RESOLUTION HOLDING HEARING ON APPEAL OF LARRY KUEL (OWNER) ON A DENIAL OF TYPE 2 DESIGN ALTERNATIVES FOR A PUBLIC HEARING SITE PLAN FOR PROPERTY LOCATED AT 4424 SOUTHEAST 14TH STREET

Communication from the City Plan and Zoning Commission advising that at their July 20, 2023 meeting, the following action was taken regarding a request from Larry Kuel (owner) for review and approval of a Public Hearing Site Plan "Donna's Garage," for property located at 4424 Southeast 14th Street, and for the following denied Type 1 Design Alternatives in accordance with City Code Sections 135-9.2.4(B) and 135-9.3.1(B):

SITE-2022-000059

DATE: 06/05/2023
SCALE: 1"=10'
DRAWN BY: M.GURIGUS
PROJECT: 22-037
STATUS: PRELIMINARY
C-106 - LANDSCAPING SHEET

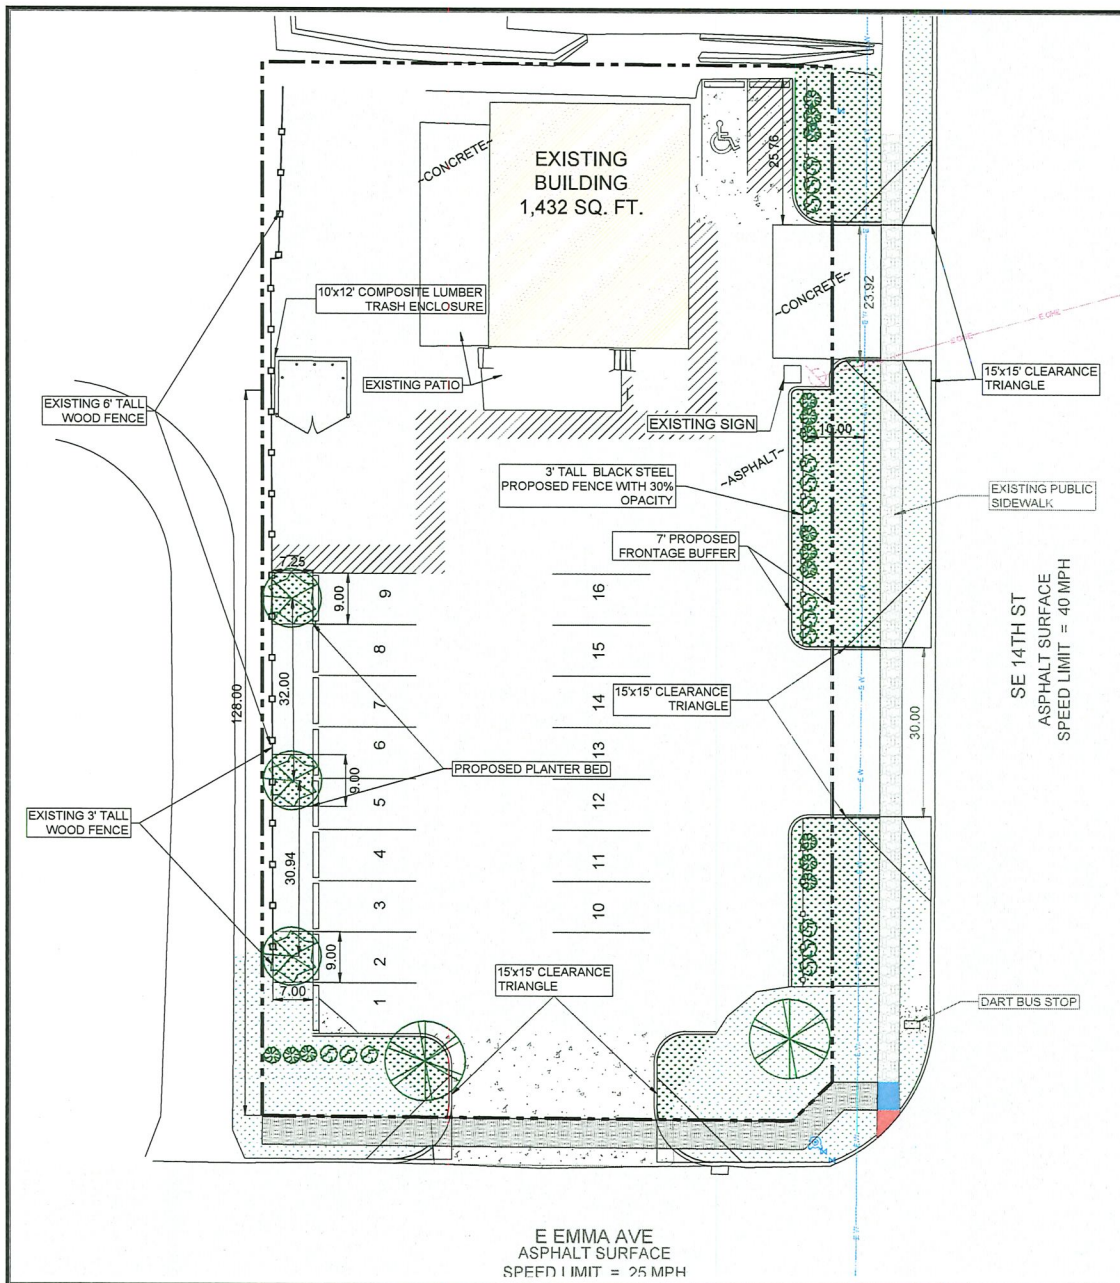
Carol Maher asked about the note on the site plan indicating use of washed river rock stone.

Wally Pelds indicated that they could change that if not allowed.
